HARTZELL PROPELLER INC.
SERVICE BULLETIN
HC-SB-61-388
Propeller - 835-39() Spinner Assembly

C. Reason

- (1) Hartzell Propeller Inc. has received reports of damage to spinner domes on affected propellers caused by interference between the counterweight/blade clamp hardware and the spinner dome.
- (2) Hartzell Propeller Inc. designed the D-5771() spinner dome to provide additional clearance between the counterweight/blade clamp hardware and the spinner dome on affected propellers.

Spinner Dome Circumference Inspection
Figure 1

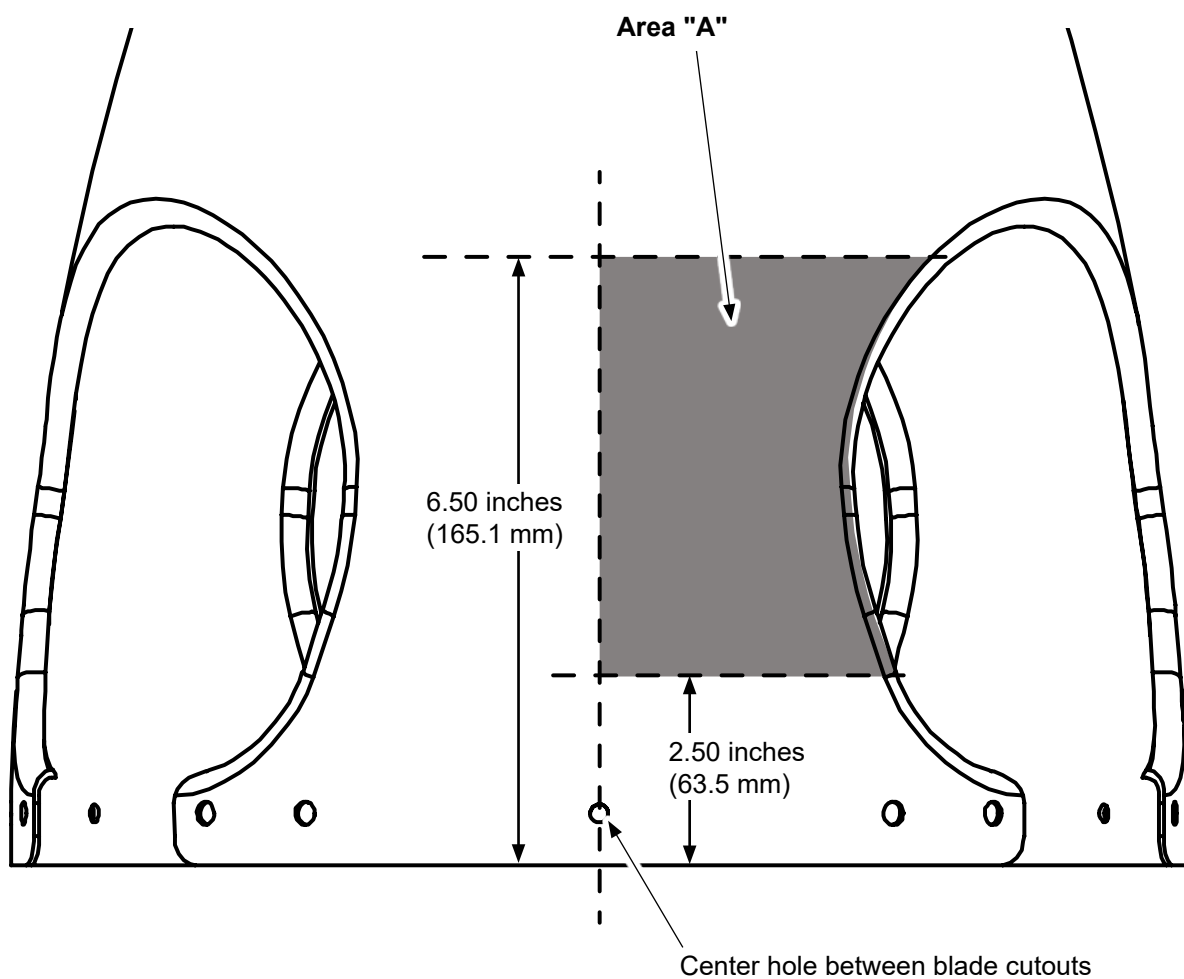
- (1) Measure the circumference around the outside of the spinner dome at the location shown in Figure 1.
 - (a) If the circumference is 36.0 inches (914 mm) or larger, the spinner assembly can remain in service/inventory.

- 1 For a spinner dome installed on a propeller:
 - a Remove the spinner dome in accordance with Hartzell Propeller Inc. Propeller Owner's Manual 139 (61-00-39).

- b Using a vibratory engraving tool, mark "SB388" on the inside of the spinner dome at the midpoint between two of the blade cutouts.
 - c Install the spinner dome in accordance with Hartzell Propeller Inc. Propeller Owner's Manual 139 (61-00-39).

- b Return the spinner dome to inventory.
 - (b) If the circumference is less than 36.0 inches (914 mm):
 - 1 For a spinner dome installed on a propeller, perform the "Spinner Dome Damage Inspection" in this section.

- 2 For spinner assemblies and spinner domes in inventory, retire/discard the spinner dome and the matched spinner bulkhead (if applicable).

Spinner Bulkhead Removal/Installation
Figure 3

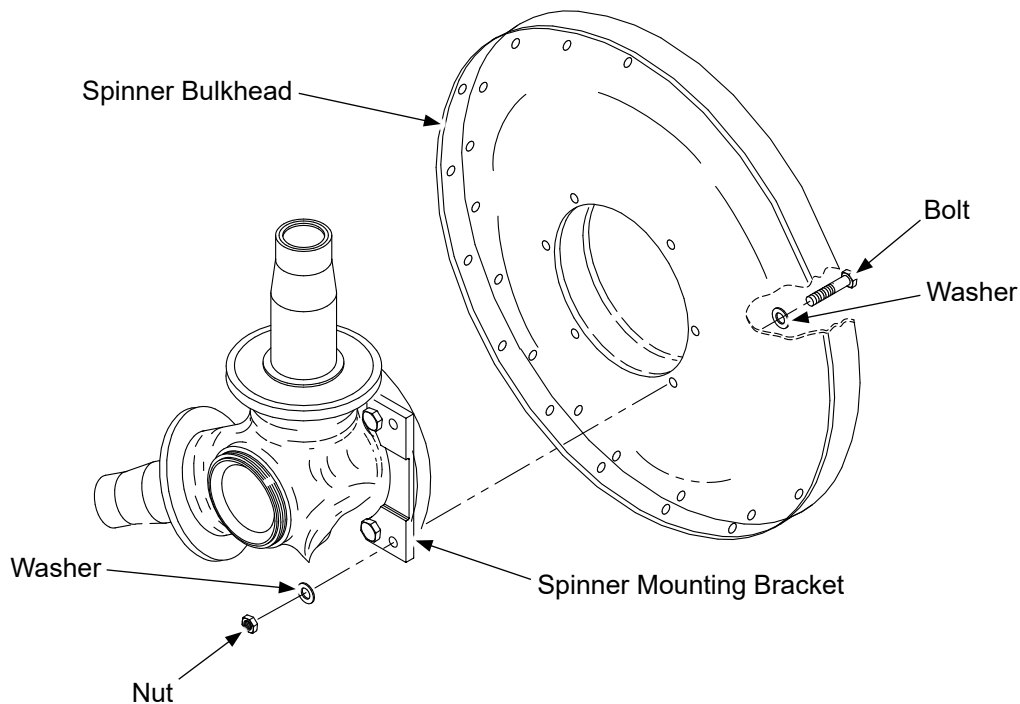
- (b) For non-de-iced propellers, remove the nuts, washers, and bolts that attach the spinner bulkhead to the hub. Refer to Figure 3.

- 1 If spinner replacement is performed between overhauls, the nuts, washers, and bolts can be reused.
 - 2 If spinner replacement is performed at overhaul, discard the hardware and install new nuts, washers, and bolts.
- (c) Retire/discard the spinner dome and the spinner bulkhead.

- (b) For non-de-iced propellers, attach the spinner bulkhead to the hub in accordance with the following steps and Figure 3:
 - 1 If replacement is performed between overhauls, install the spinner bulkhead using the nuts, washers, and bolts removed at disassembly.

- 2 If replacement is performed at overhaul, install the spinner bulkhead using the new nuts, washers, and bolts.
 - 3 Torque the nuts to 90-120 In-Lbs (10.2-13.5 N•m).
